### Proposed Revisions to a Standard Plans Index

Index Number: 550-011

Index Title: BRIDGE FENCING (CURVED TOP)

LAST REVISION 11/01/17	REVISION 11/01/23	DESCRIPTION:		FY 2023-24 STANDARD PLANS	BRIDGE FENCING (CURVED TOP) ON PARAPET (CURVED TOP)	INDEX 550-011	SHEET 1 of 3
---------------------------	----------------------	--------------	--	------------------------------	---	------------------	-----------------

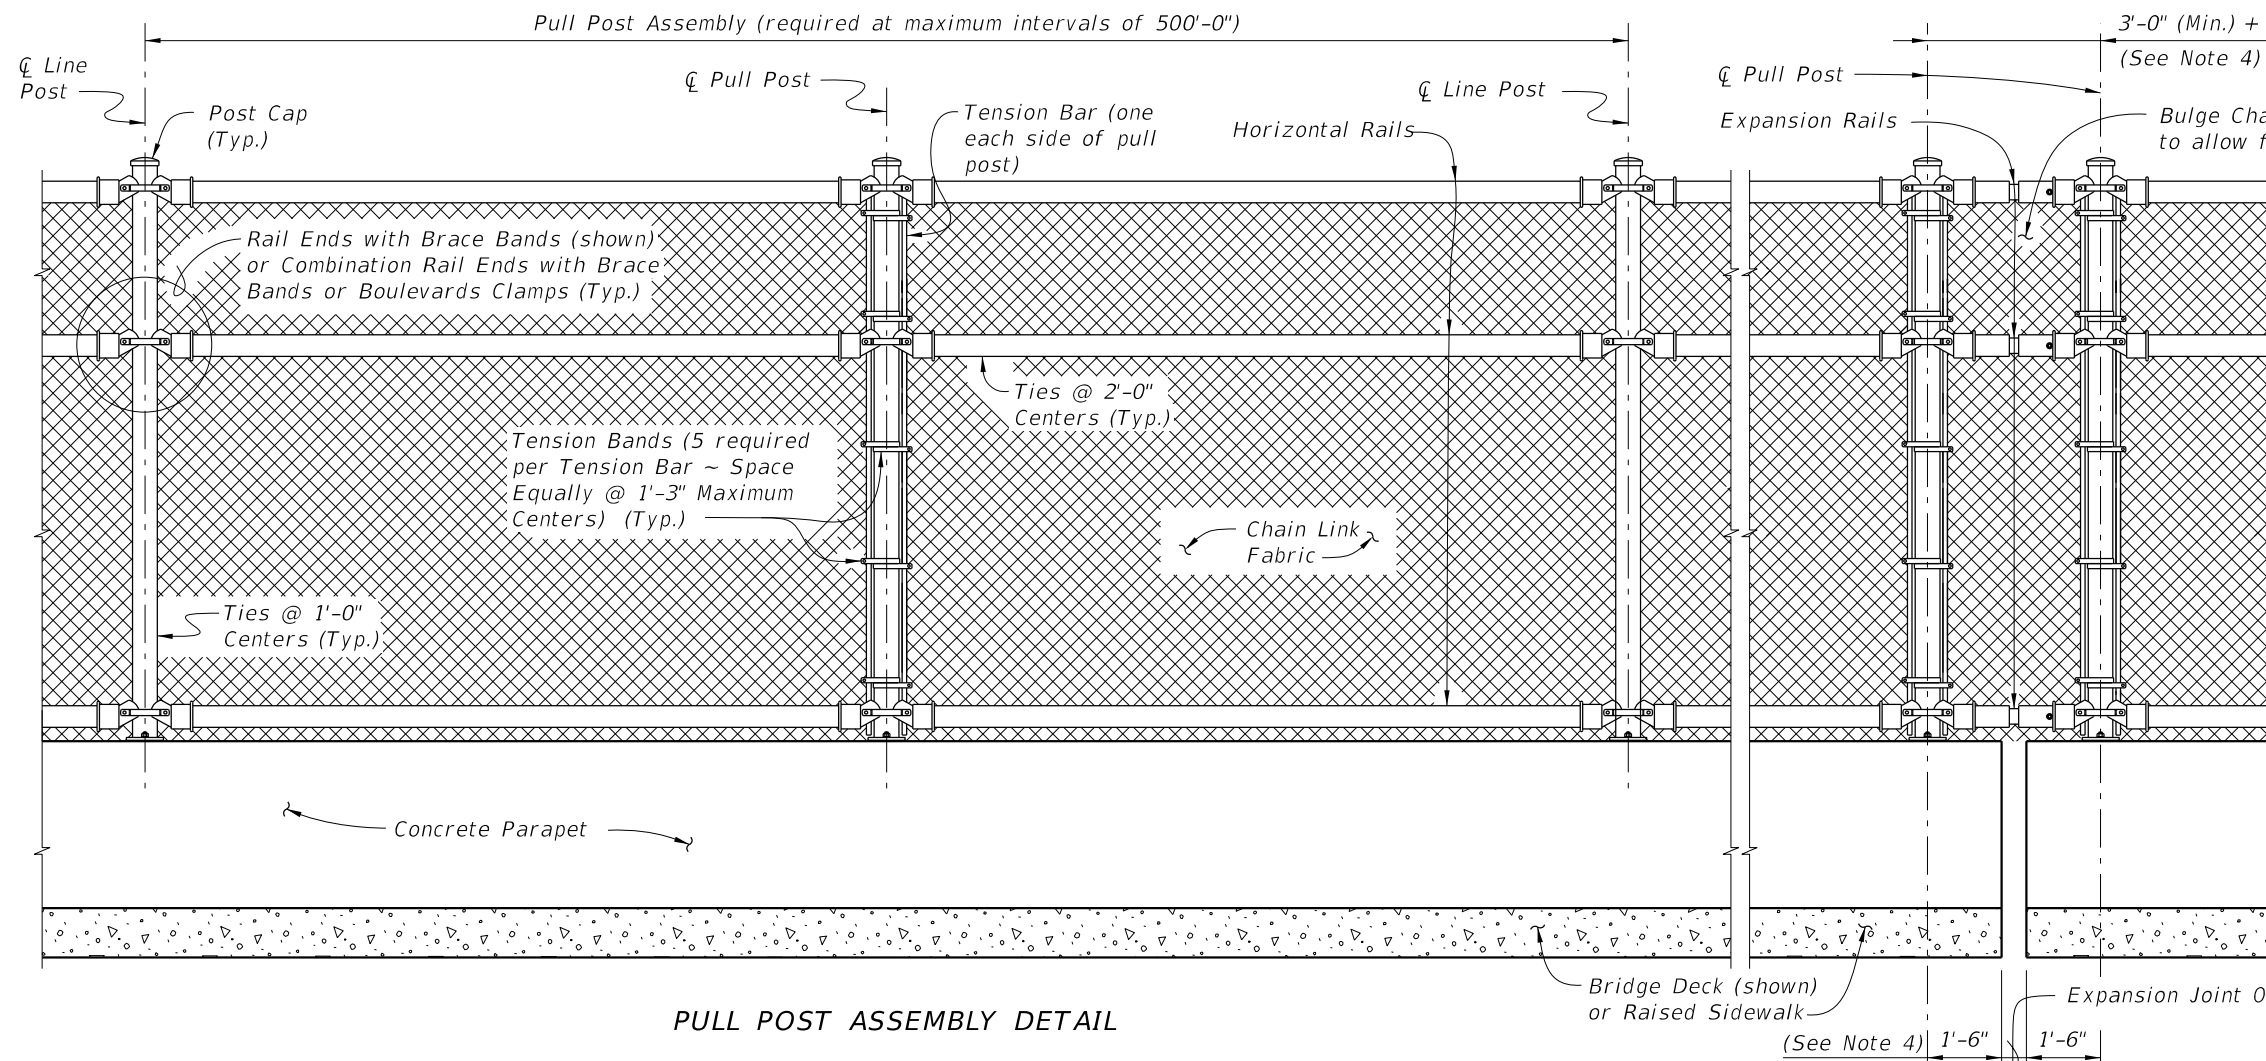
Sheet 1: Change sheet title.

LAST REVISION 11/01/23	REVISION	DESCRIPTION:		FY 2024-25 STANDARD PLANS	BRIDGE FENCING ON PARAPET (CURVED TOP)	INDEX 550-011	SHEET 1 of 3
---------------------------	----------	--------------	--	------------------------------	--	------------------	-----------------

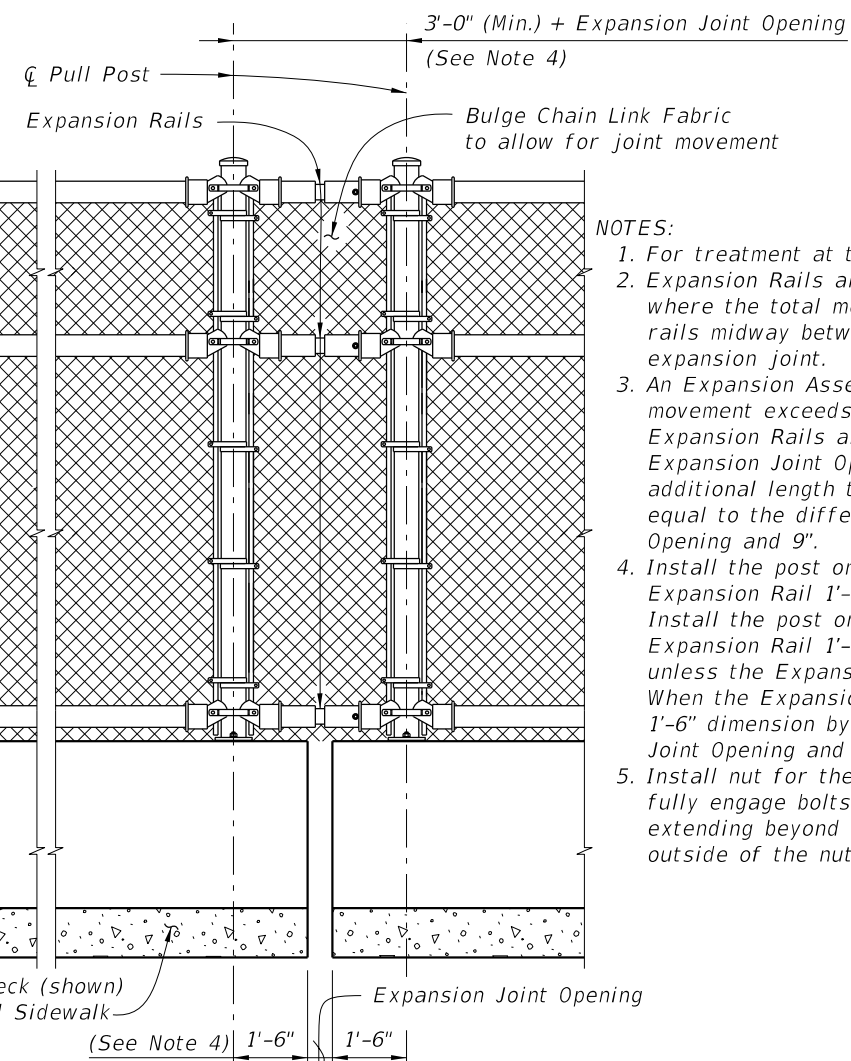
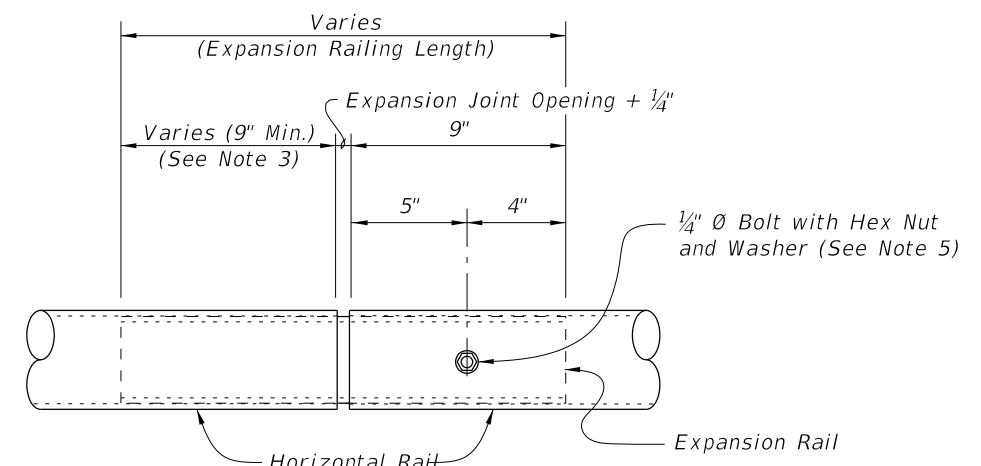
Sheet 2: Change sheet title.

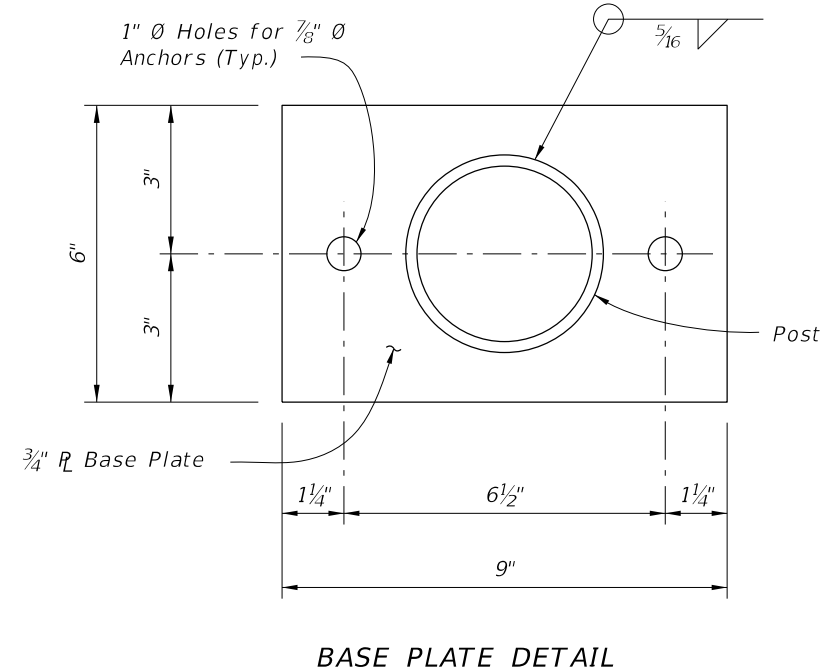
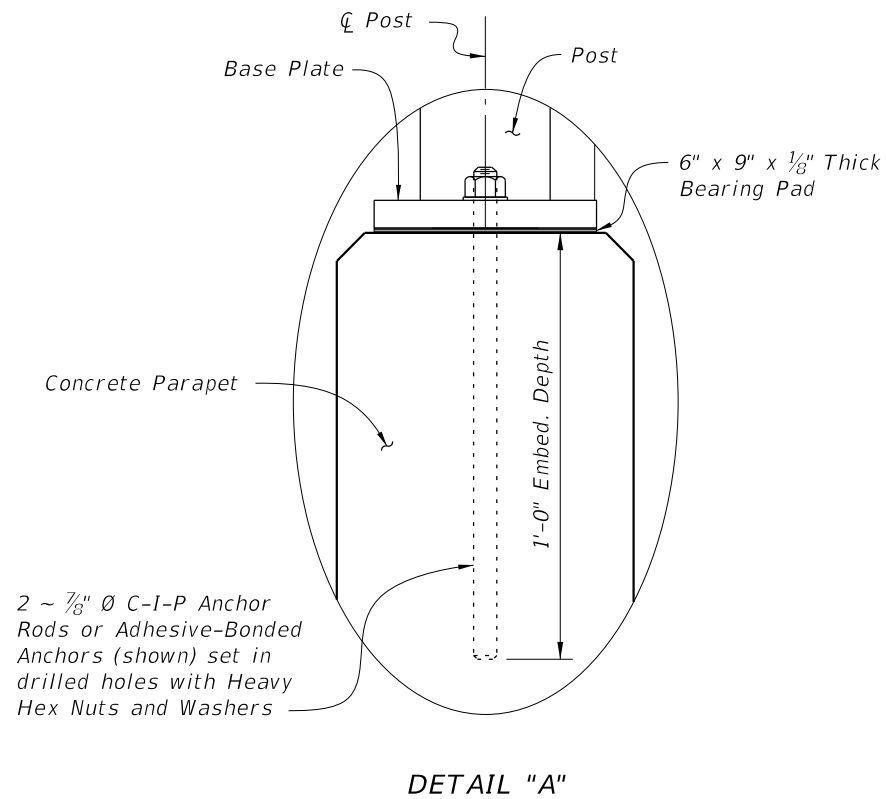
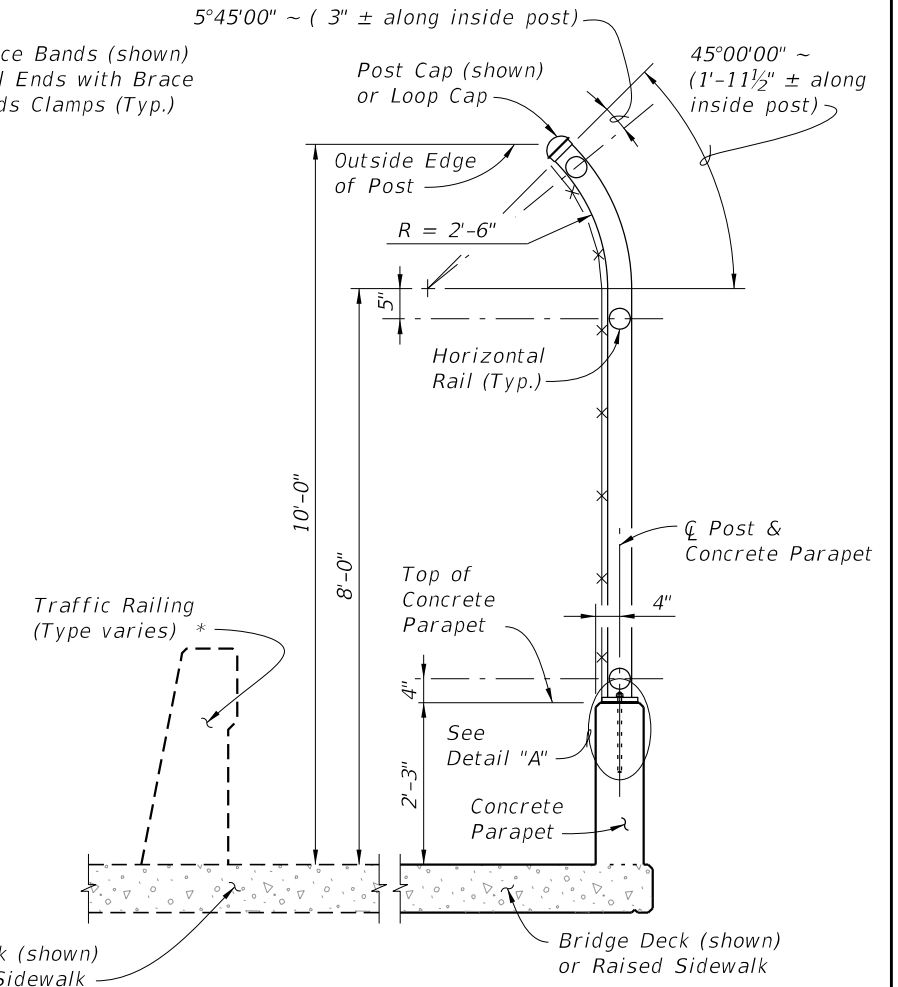
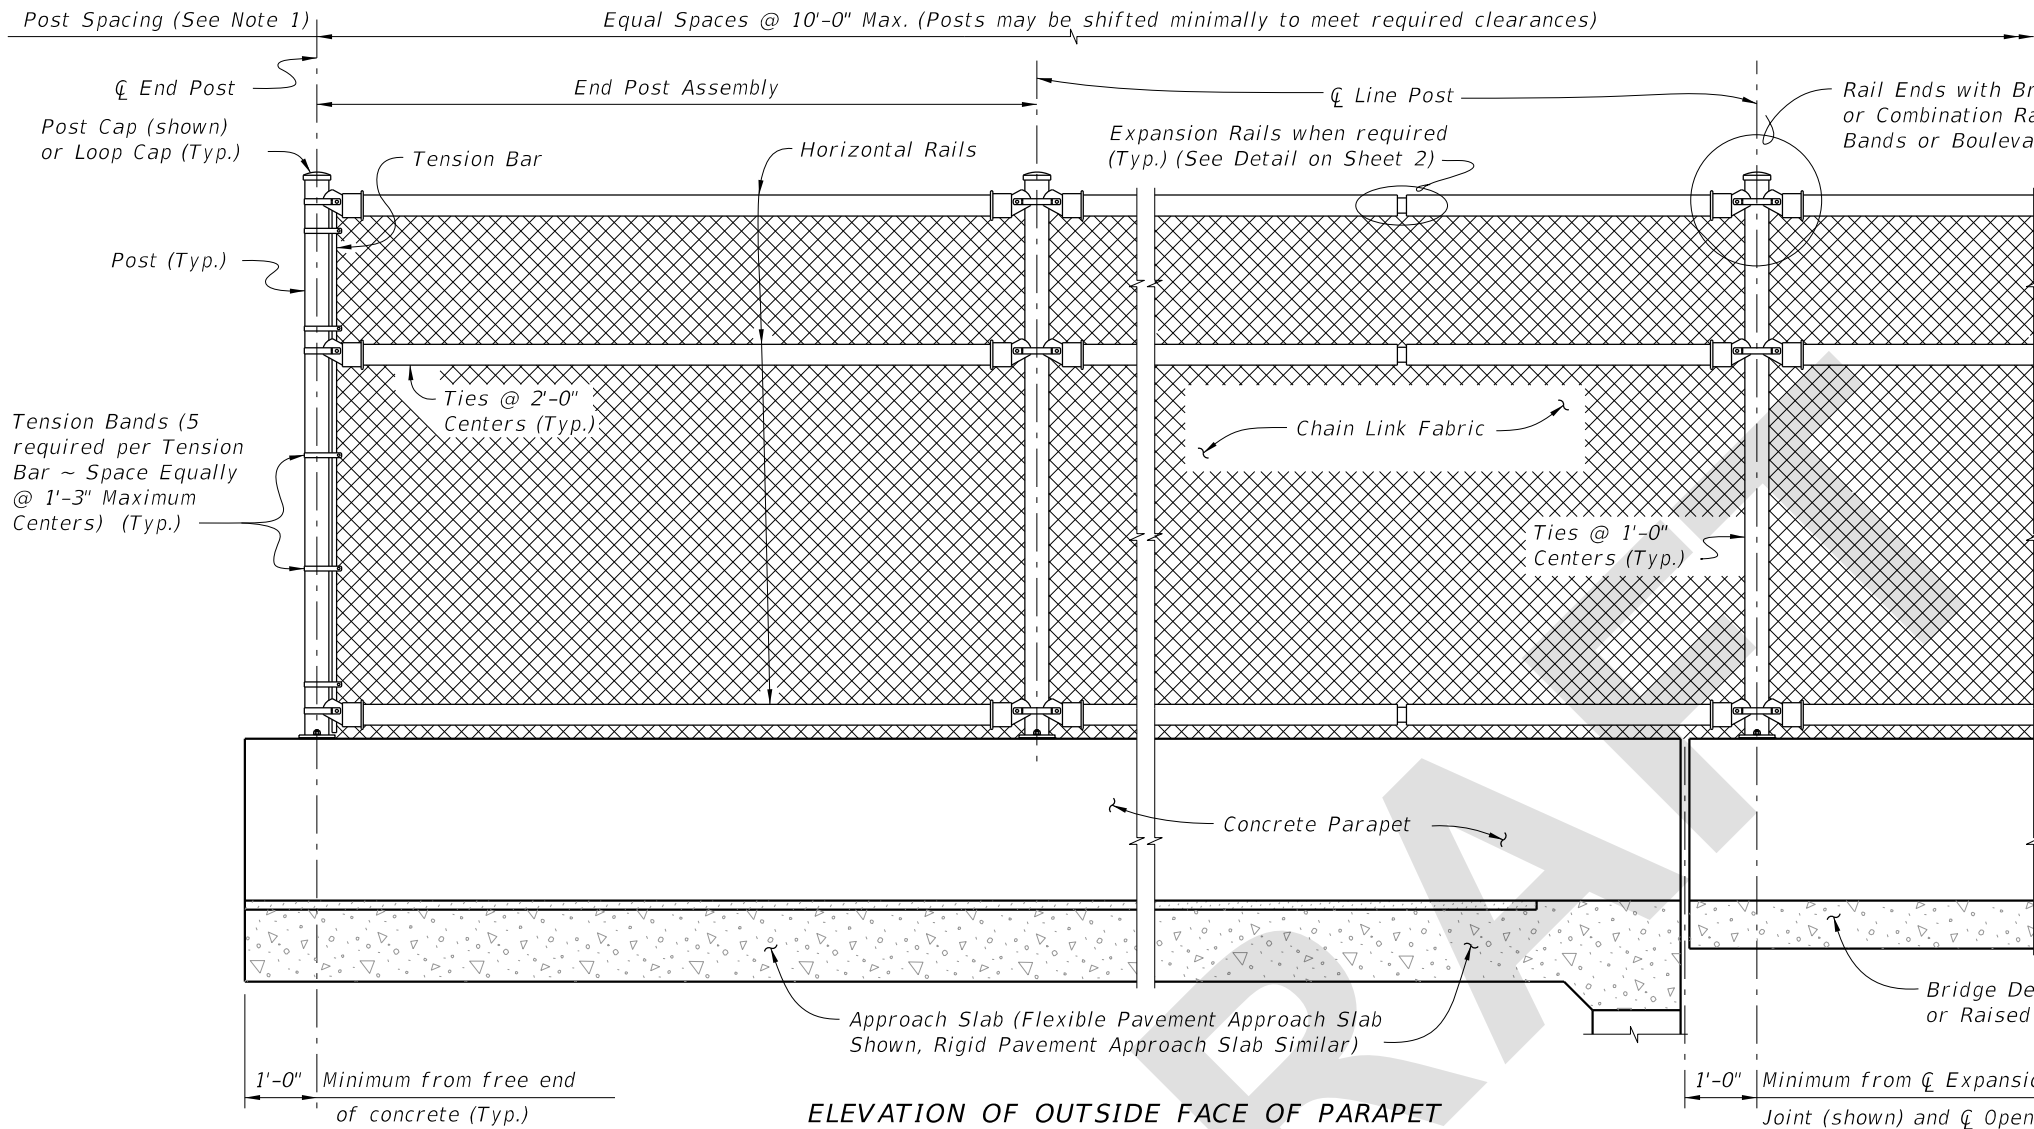
Sheet 3: Change sheet title.

LAST REVISION 11/01/23	REVISION	DESCRIPTION:	 <b>FY 2024-25 STANDARD PLANS</b>	<b>BRIDGE FENCING ON PARAPET (CURVED TOP)</b>	INDEX <b>550-011</b>	SHEET <b>3 of 3</b>
---------------------------	----------	--------------	---	---	-------------------------	------------------------
